Amendment No. 0004
29 August 2002

SUBJECT: **Amendment No. 0004** to Request for Proposal Solicitation Package
for Design and Construction of **REPLACE FAMILY HOUSING, MINOT AFB, ND.**
Solicitation No. DACA45 02 R 0024.

DATE	28-AUG-02
PROJECT	REPLACE FAMILY HOUSING
CLIENT	U.S. ARMY ENGINEER DISTRICT CORPS OF ENGINEERS OMAHA, NEBRASKA
LOCATION	NORTH DAKOTA
PROJECT NO.	AF 711-90-02
DATE	28-AUG-02
BY	
CHECKED BY	
APPROVED BY	
SCALE	1" = 50'
SHEET NO.	P1.18

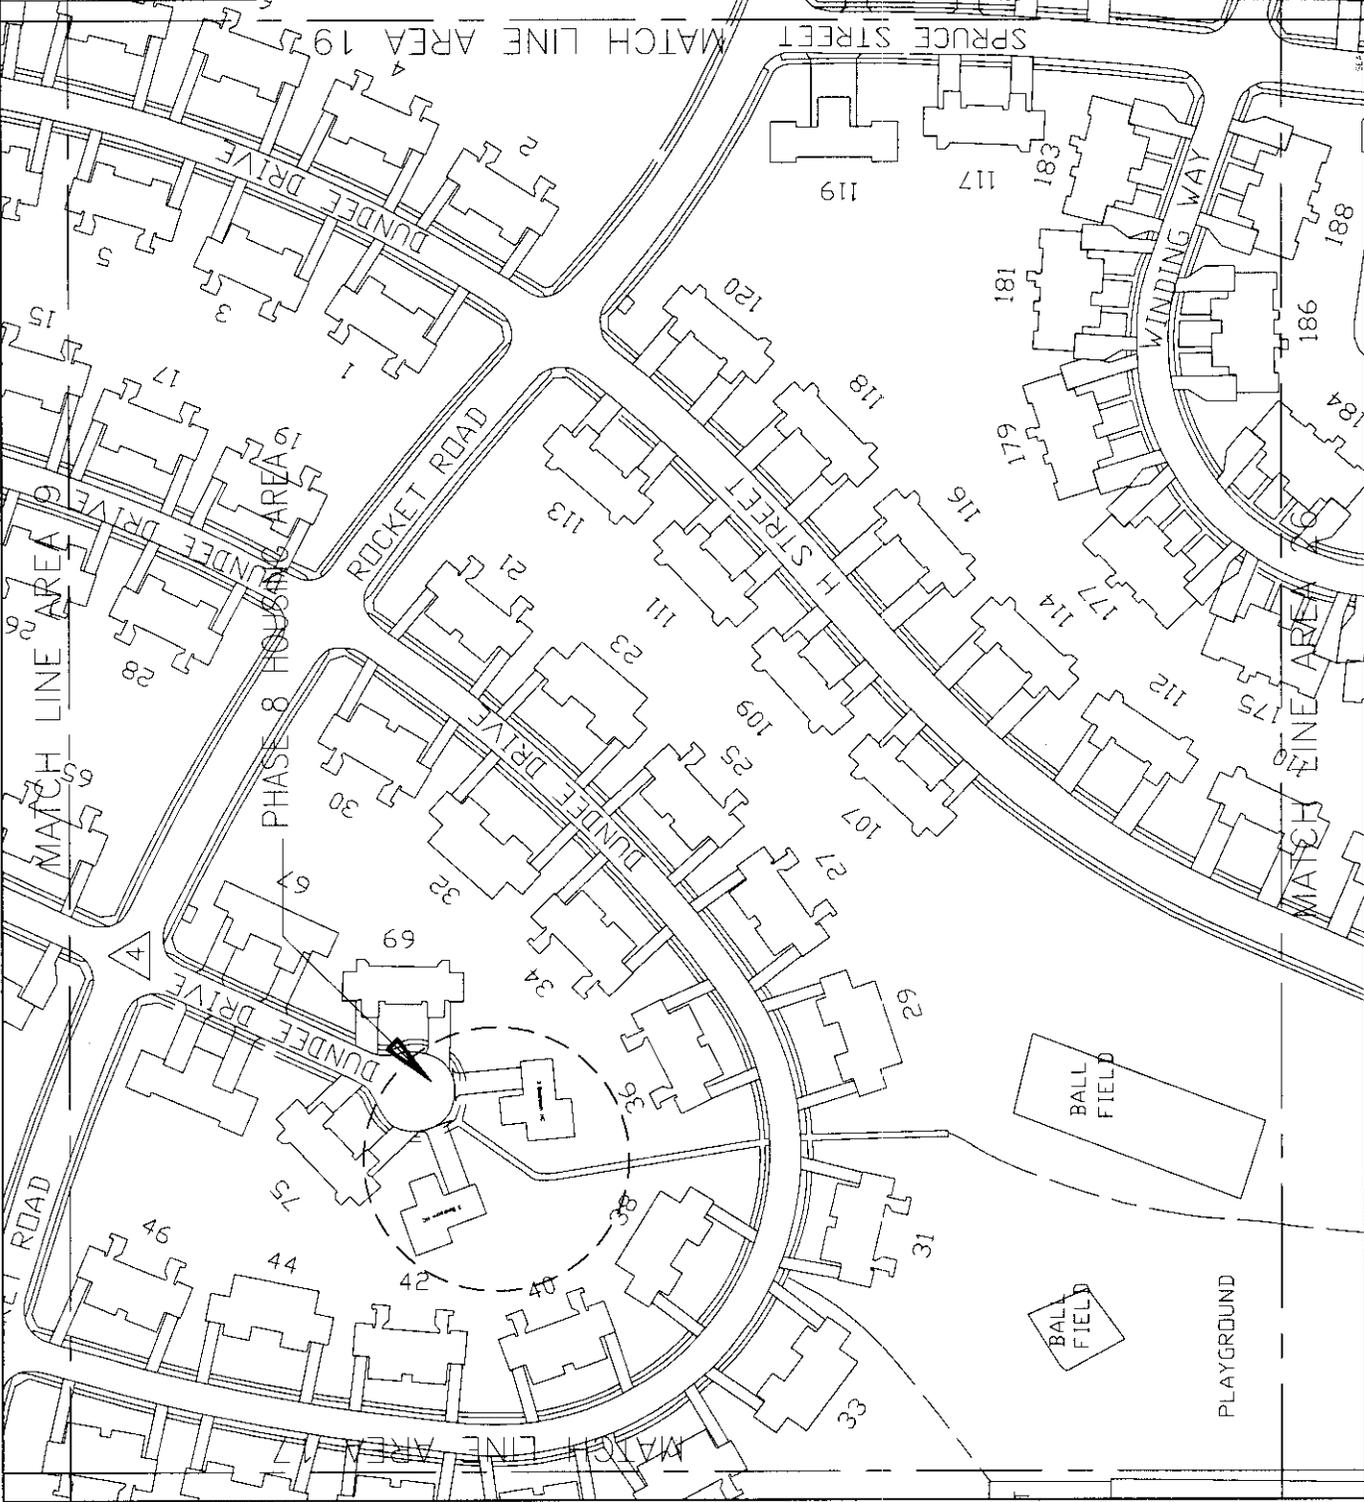
1. Revise drawing sheets P1.18, R1.18 and P1.38 in accordance with attached sketches.
